MONTGOMERY COUNTY DEPARTMENT OF PARK AND PLANNING

MEMORANDUM

REVIEW TYPE: Site Plan
APPLYING FOR: 450 multi-family dwelling units and 820,000 square feet of office and 30,000 square feet of retail
PROJECT NAME: Fortune Parc
CASE #: 8-04015
REVIEW BASIS: Site Plan Review required in the I-3 zone [59-C-5.437] as set forth in division 59-D-3.
Section 59-C-1.61 for development including Moderately Priced Dwelling Units
ZONE: I-3
LOCATION: Northwest intersection of Montrose Road and Interstate 270 on Montrose Road and Seven Locks Road
MASTER PLAN: Potomac Master Plan
APPLICANT: Fortune Parc Development Partners
FILING DATE: November 24, 2003
HEARING DATE: February 26, 2004

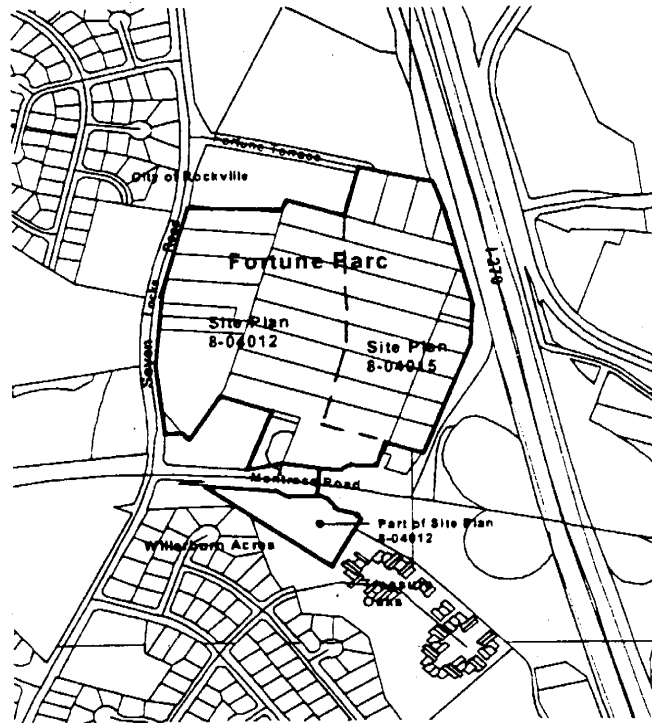
A waiver to reduce the building and parking setbacks from the property boundary at the I-270 off-ramp is being requested by the applicant. The applicant cites Section 59-C-5.4392(b)(2)(F) of the Zoning Ordinance, which provides the Planning Board the authority to approve a reduction from the required setbacks. The applicant is requesting a reduction of the required building setback from 100 feet to 85 feet and for the required parking setback from 50 feet to 35 feet between stations 541+01.93 to 541+55.95. The area within the boundaries of these station points protrudes into the site by approximately thirty feet.

M-NCPPC staff believes the small triangular portion of the right-of-way that protrudes into

the site should not alter the layout of the building and parking within the station points referenced on the site plan. Staff accepts the justification offered by the applicant and has asked the applicant to increase the planting along the right-of-way to offset the reduction and provide additional screening from I-270.
